Notice of Allowability	Application No.	Applicant(s)	
	09/961,245	SUZUKI ET AL.	
	Examiner	Art Unit	
	Guillermo Munoz	2637

DETAILED ACTION

Required Correction of Drawings

FIG. 1

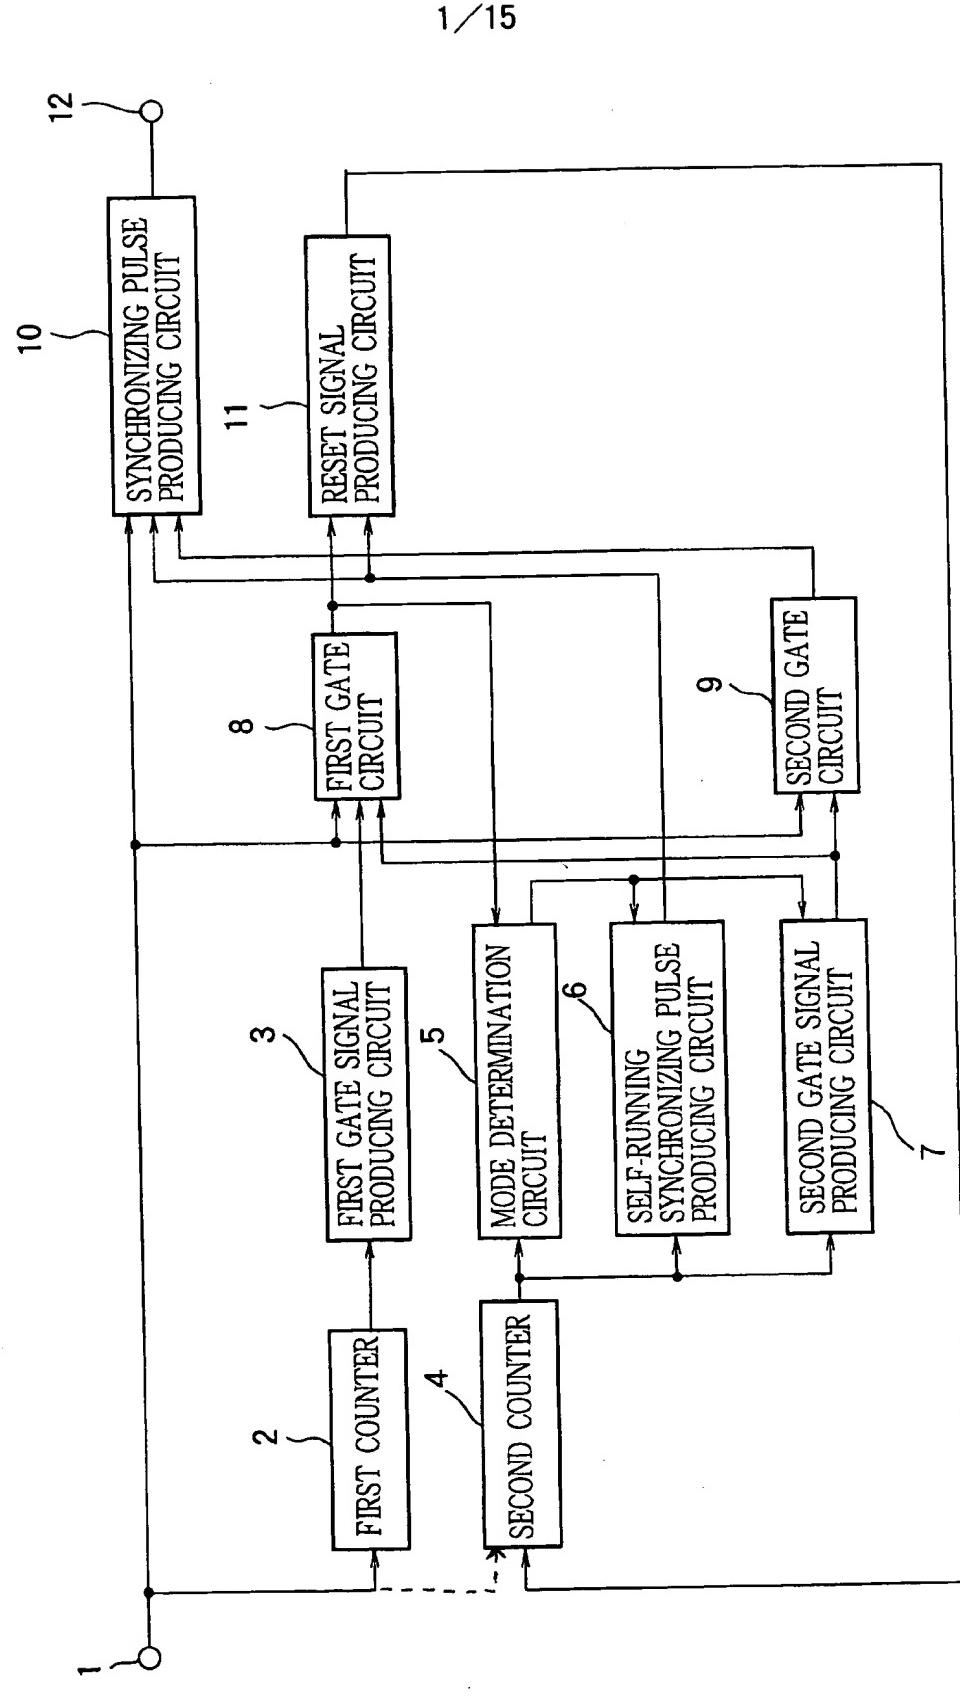
The drawings require modification to include claimed feature “second counter counting the clock” in claim 1 line 14. Figures 1 and 7 have been included in this office action having required changes illustrated by examiner. The corrected Figures 1 and 7 must show the clock of a predetermined frequency input into the second counter. Corrected drawing sheets in compliance with 37 CFR 1.121(d) are required in reply to the Office action to avoid abandonment of the application. Any amended replacement drawing sheet should include all of the figures appearing on the immediate prior version of the sheet, even if only one figure is being amended. The figure or figure number of an amended drawing should not be labeled as “amended.” If a drawing figure is to be canceled, the appropriate figure must be removed from the replacement sheet, and where necessary, the remaining figures must be renumbered and appropriate changes made to the brief description of the several views of the drawings for consistency. Additional replacement sheets may be necessary to show the renumbering of the remaining figures. Each drawing sheet submitted after the filing date of an application must be labeled in the top margin as either “Replacement Sheet” or “New Sheet” pursuant to 37 CFR 1.121(d). If the changes are not accepted by the examiner, the applicant will be notified and informed of any required corrective action in the next Office action. The objection to the drawings will not be held in abeyance.

• Illustrated as broken line arrows
